NEWS Trailer

74912201e

16.02.2022

Shock absorber attachment for Airlight II versions with welded axle seats and square axle beam

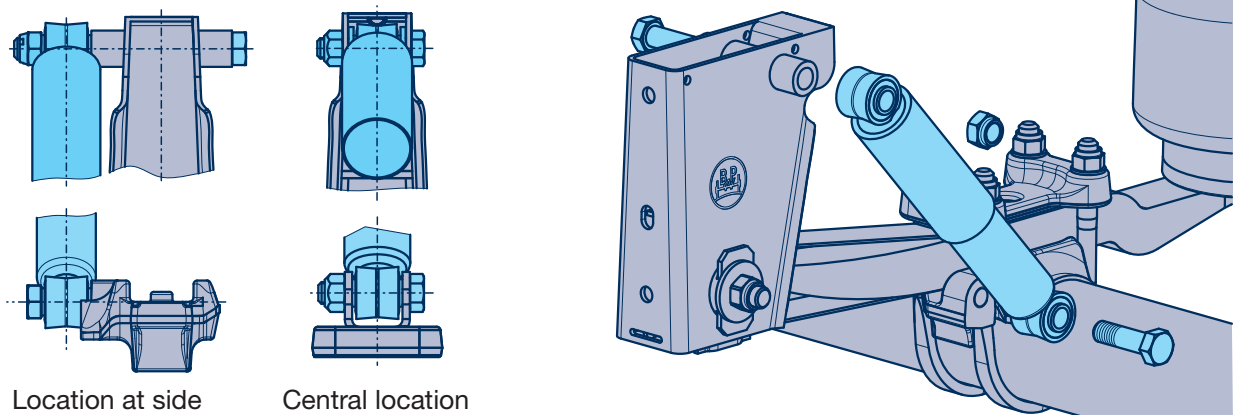
After all Airlight II versions with round axle beam are equipped with the new bolt solution as standard, versions with square axle beam and welded axle seat (welded axle plates) will now be changed. The change will take place from week 11 / 2022.

There will be a changeover from welded bolt to screw solution. The new solution is also known from the ECO Air program.

Depending on the version, shock absorbers can be arranged in different ways, e.g. to the side of the air suspension hanger bracket or in the center of the air suspension hanger brackets. The shock absorbers are fastened using M 24 bolts.

Depending on the design, additional rings, washers and sleeves may be required during installation.
